MEMORANDUM

Attention: Glenn Starr, Taumatotara Wind Farm Limited
Date: 9 December 2020
From: Simon Chapman, Principal Ecologist
Subject: Taumatotara (T4) Wind Farm – s92 response – Bats

Appendix 1: Map showing suggested pest control programme areas (red circles), and relevant landscape context (purple circles: recently felled forestry area (left) and large native area to be avoided by the revised proposal (right))

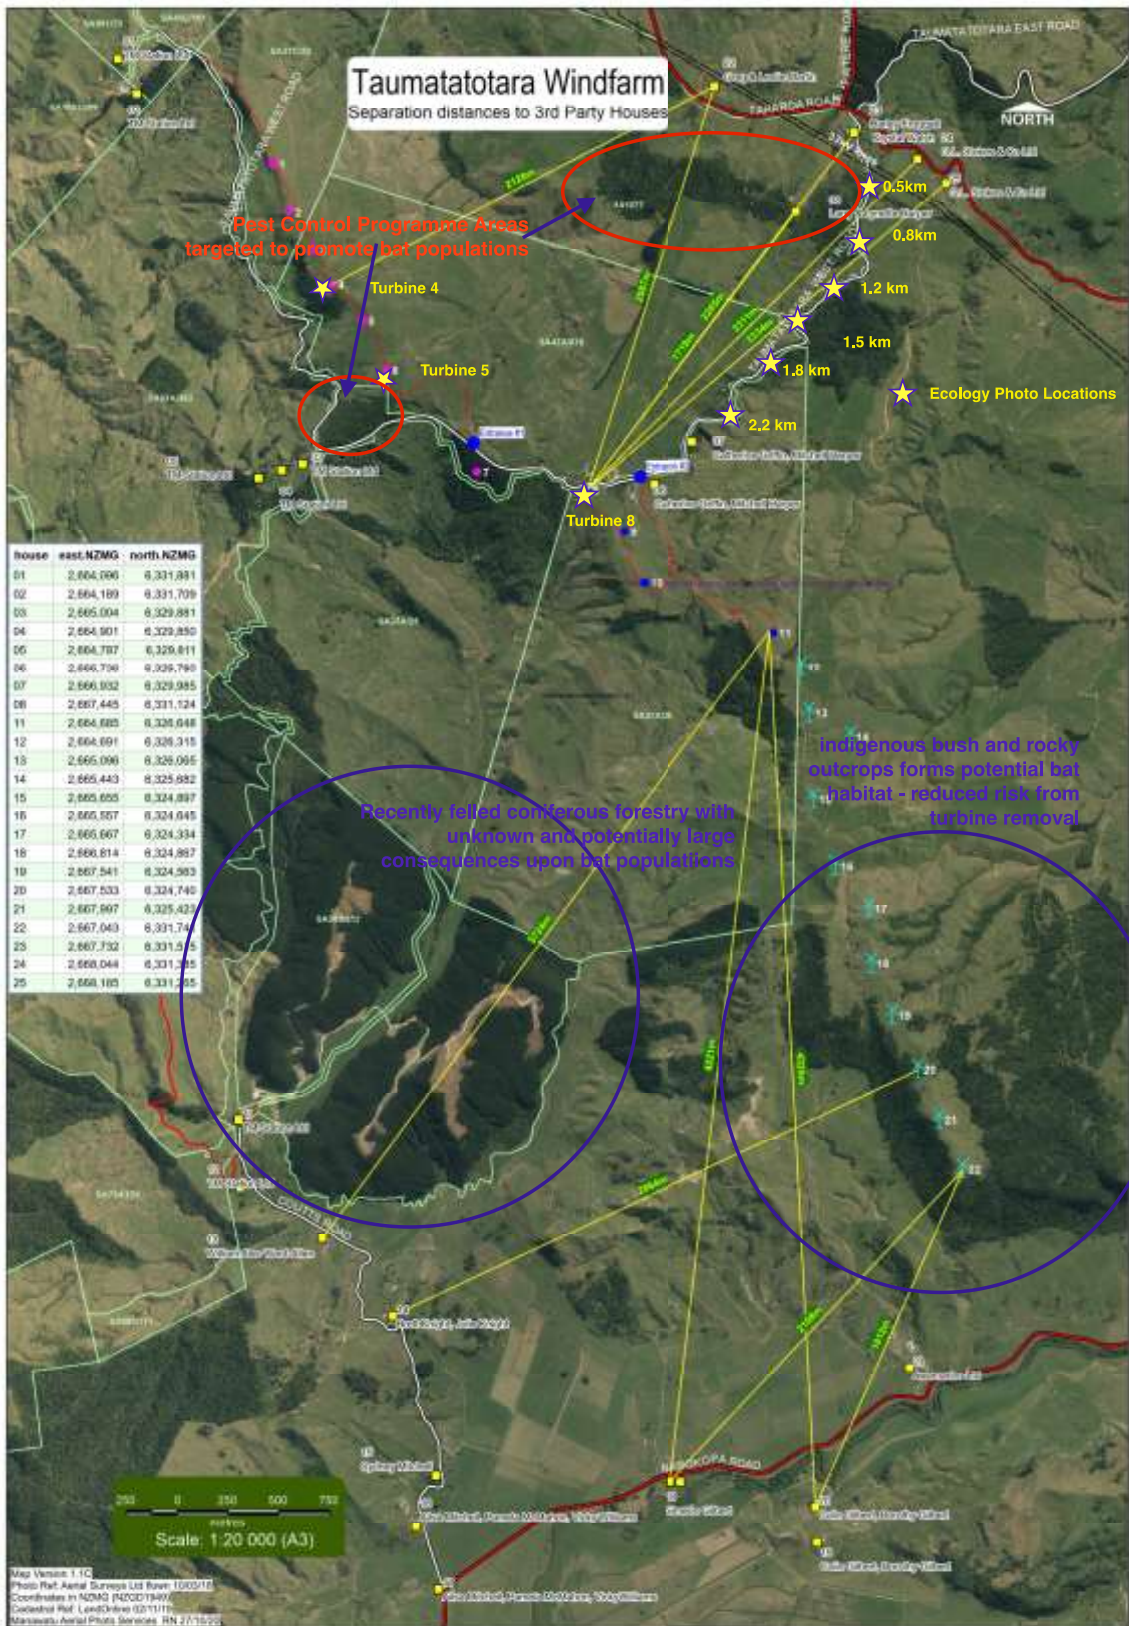
1. From the southern end of the site to the northern end (Appendix 1)
2. A transfer from lower height upwards that will increase ground clearance (Appendix 2; Shown in yellow to the higher height as shown in green and added to turbines 1 to 11)
3. The avoidance of turbines near the high-quality native forest habitat for bats adjacent to turbines 17 to 22 (Appendix 4)

The third point of consideration requires observations and comparisons of the existing potential habitat at Turbines 12 – 22 vs Turbines 1 – 11. What is immediately obvious from aerial image mapping is that the intact native forestry fragments (which is likely to provide relatively high quality areas of bat habitat) are much larger around the (consented) Turbine 12 – 22 turbine block which is proposed to be surrendered as part of this application (Appendix 1). There is also cliff and rocky outcrops along the western flank of turbines 17 to 22 which may form attractive bat habitat. Comparisons of habitat strongly suggest that current or future bat habitats are more likely adjacent to turbine block 12 to 22.

I recommend a consent condition that requires that the applicant establish a pest control programme over a minimum area commensurate with the scale of the project (e.g., 200 hectares of native forest habitat) with the primary objective of protecting key bat habitats on-site and possibly adjoining properties with suitable habitat for protection.
